File In Section: Product Campaigns
Bulletin No.: 99041
Date: May, 2000

SUBJECT: 99041 - INCORRECT FRONT AXLE STATUS SIGNAL TO EBC4 ABS

MODELS: 1991-1996 CHEVROLET AND GMC 4WD T UTILITIES
1994-1996 CHEVROLET AND GMC 4WD T PICKUP TRUCKS

Figure 1

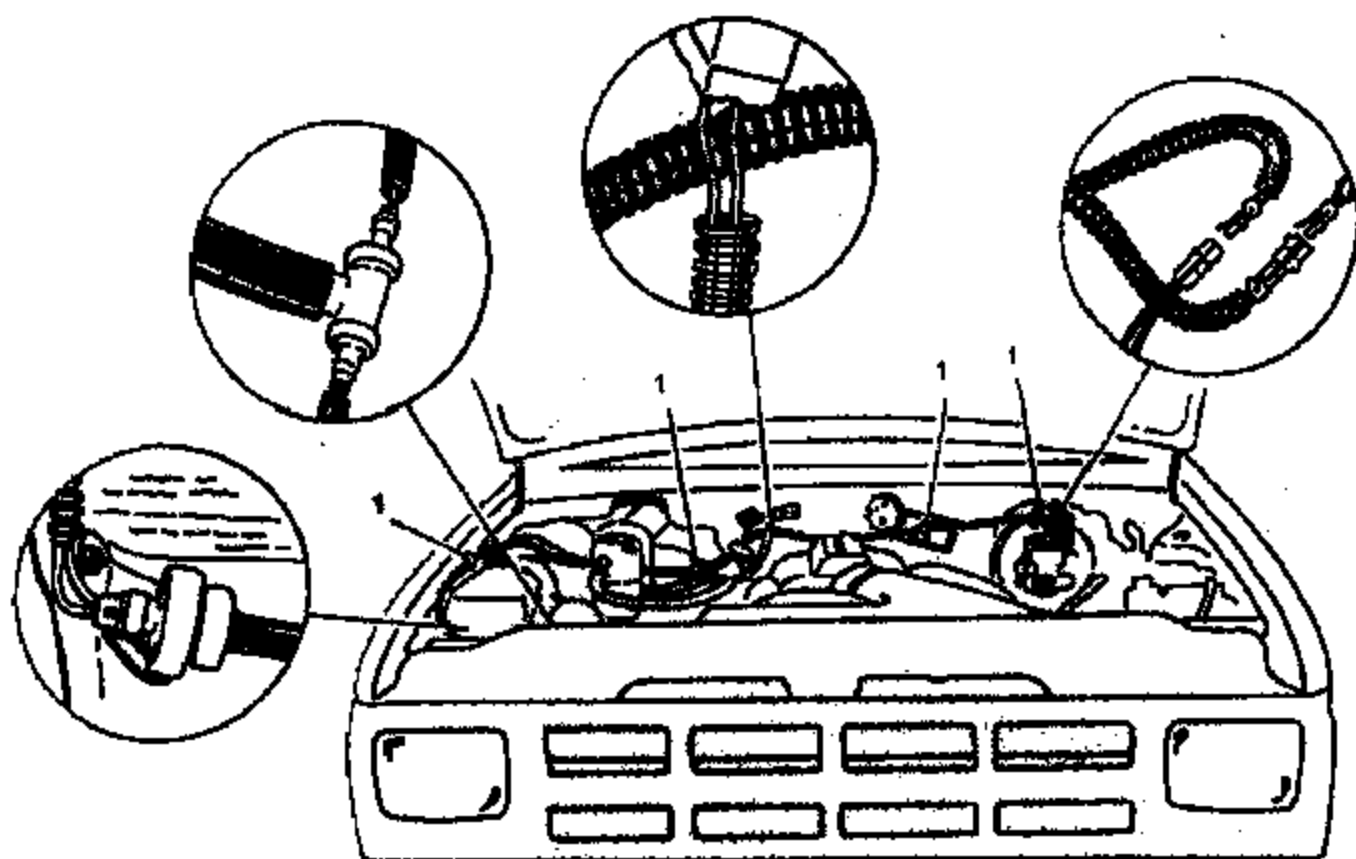
1. Disconnect the negative battery cable.
2. Remove the front lower coolant reservoir attaching bolt.
3. Install the new vacuum switch, bracket, and hose assembly at the front lower coolant reservoir attaching location using the bolt removed in the previous step.

4. Position the vacuum switch, bracket, and hose assembly as shown in Figure 1 and tighten the bolt to 8 Nm (71 lb in).
5. Locate the vacuum hose leading from the front axle vacuum actuator, located under the battery tray, to the vacuum switch mounted on the transfer case. This vacuum hose typically is routed along the right front frame rail rearward up along the wheel well towards the cowl area of the engine compartment. On some vehicles this hose may be covered with a black convoluted protective sleeve.
6. Select a point on the vacuum hose, which was located in the previous step, that will be lower in the vehicle than the new vacuum switch and will not result in the loading or stretching of either the existing or new hoses when they are connected together.

9. Route the new harness as shown in Figure 1 and secure it to the existing underhood components at the locations indicated (1) using the tie straps provided in the kit.
10. Locate and disconnect the existing underhood front axle switch wiring harness connector, located in the area above the brake booster assembly, and jumper in the new wiring harness.
11. Raise the vehicle and suitably support.
12. Locate the transfer case selector switch positioned on top of the transfer case.
13. Remove any foreign material from around the transfer case selector switch or vacuum connector.

Figure 2

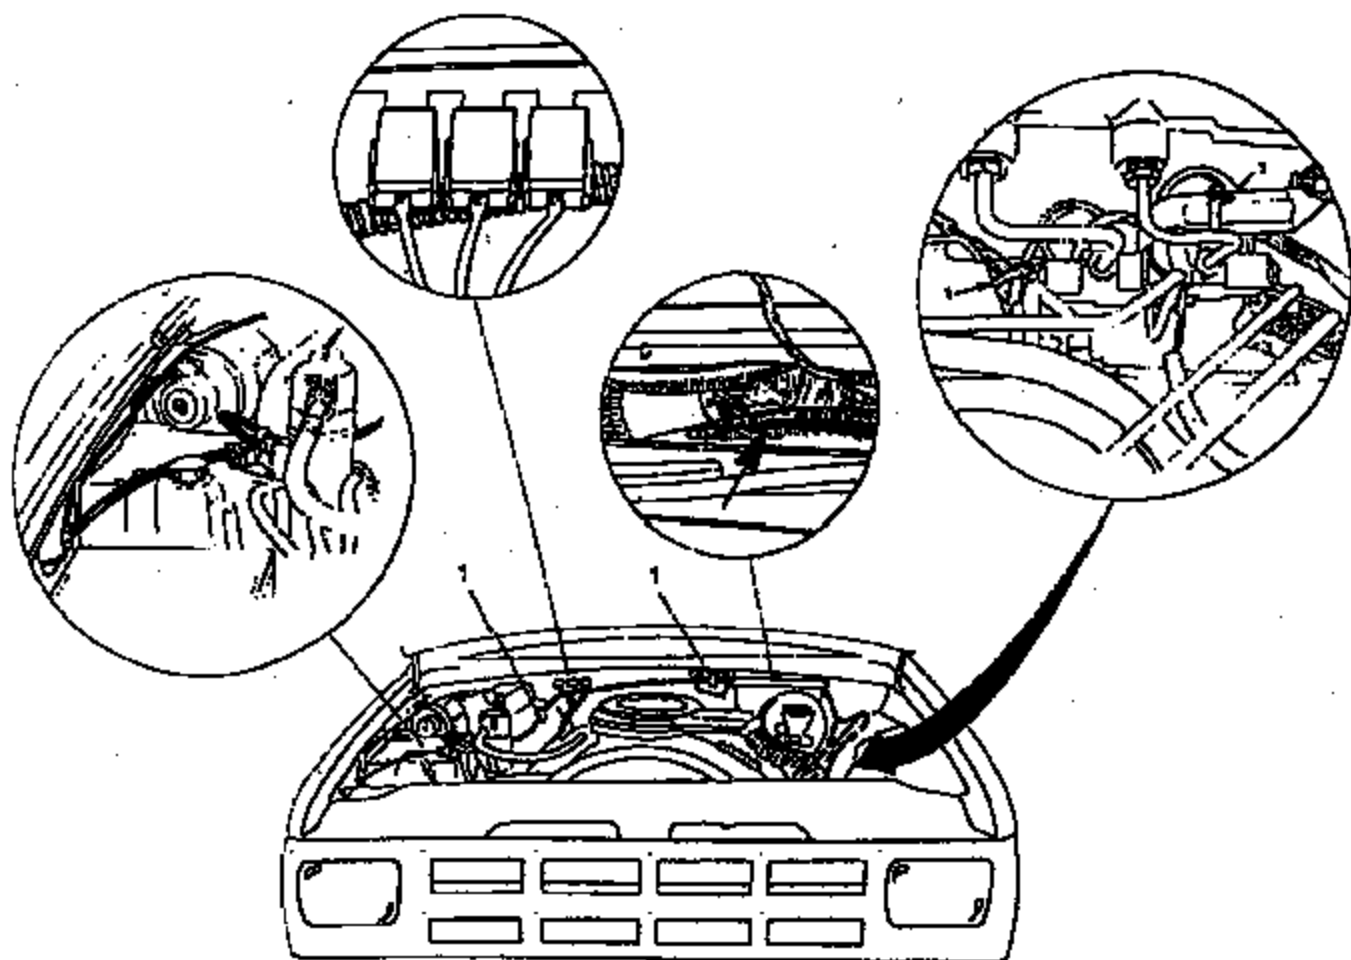
1. Disconnect the negative battery cable.
2. Locate the new vacuum switch, bracket, and hose assembly so that the hole in the bracket aligns with the front inboard nut that is molded into the top of the coolant reservoir as shown in Figure 2.
3. Using the bolt provided in the kit, attach the vacuum switch, bracket, and hose assembly to the coolant reservoir by hand starting the bolt.
4. With the vacuum switch, bracket, and hose assembly positioned as shown in Figure 2, tighten the bolt to 10 Nm (88 lb in).
5. Locate the vacuum hose leading from the front axle vacuum actuator, located under the battery tray, to the vacuum switch mounted on the transfer case. This hose is routed up from the axle vacuum actuator and then rearward towards the cowl area inside the right fender as shown in Figure 2.

9. Route the harness as shown in Figure 2 and secure the new harness to the existing underhood components at the locations indicated (1) using the tie straps provided in the kits.
10. Disconnect the existing underhood front axle switch wiring harness connector, located in the area of the left front inner wheel well skirt under the brake master cylinder, and jumper in the new wiring harness.

Figure 3

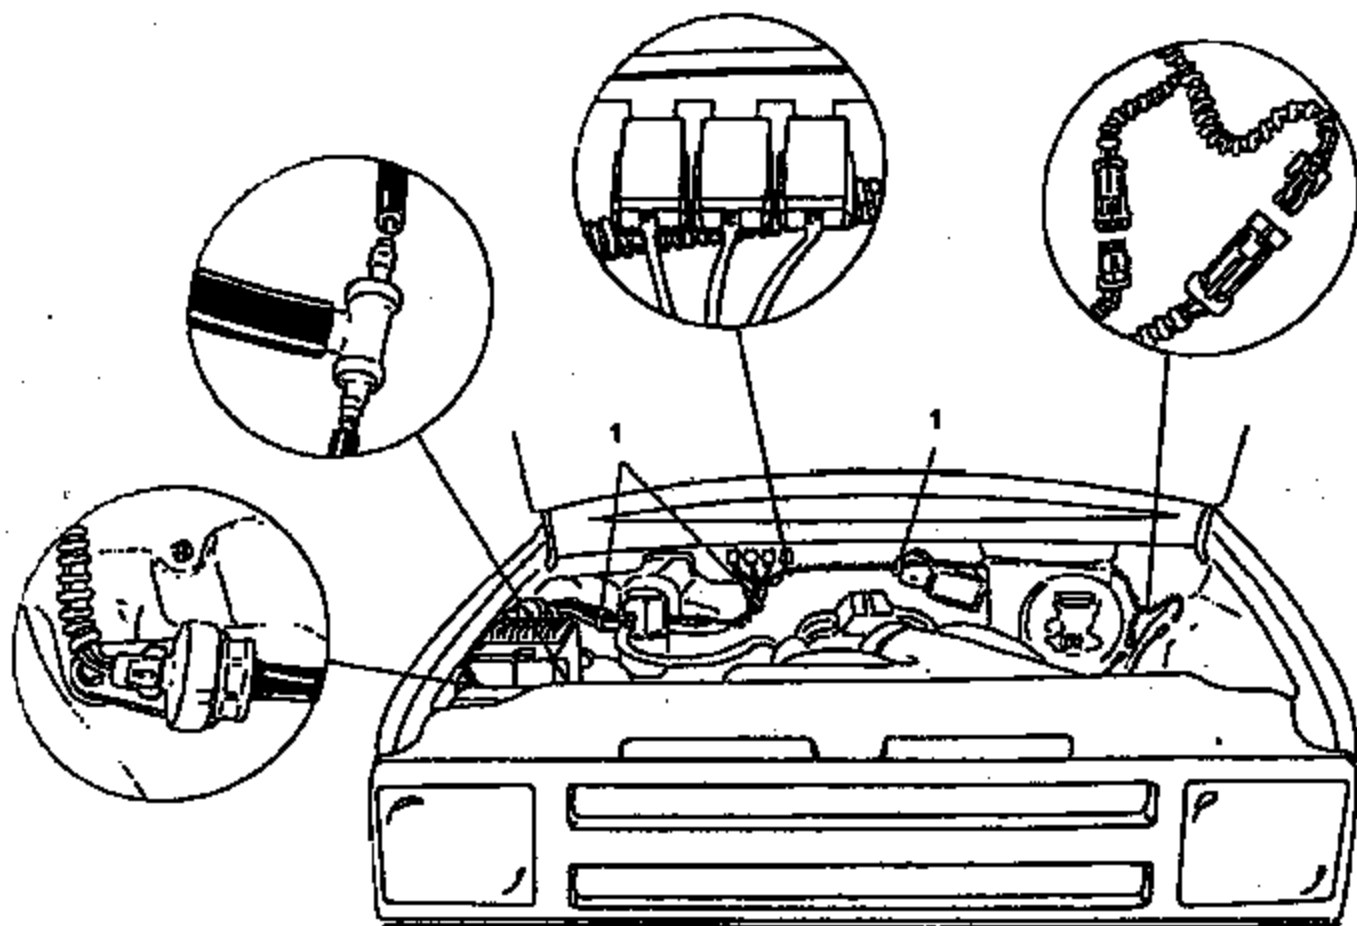
4. Position the vacuum switch, bracket, and hose assembly as shown in Figure 3 and tighten the nut to 8 Nm (71 lb in).
5. Locate the vacuum hose leading from the front axle vacuum actuator, located under the battery tray, to the vacuum switch mounted on the transfer case. This vacuum hose typically is routed along the right front frame rail rearward up along the wheel well towards the cowl area of the engine compartment. On some vehicles this hose may be covered with a black convoluted protective sleeve.
6. Select a point on the vacuum hose, which was located in the previous step, that will be lower in the vehicle than the new vacuum switch and will not result in the loading or stretching of either the existing or new hoses when they are connected together.

9. Route the new harness as shown in Figure 3 and secure it to the existing underhood components at the locations indicated (1) using the tie straps provided in the kit.
10. Locate and disconnect the existing underhood front axle switch wiring harness connector, located in the area of the left front inner wheel well skirt under the brake master cylinder, and jumper in the new wiring harness.
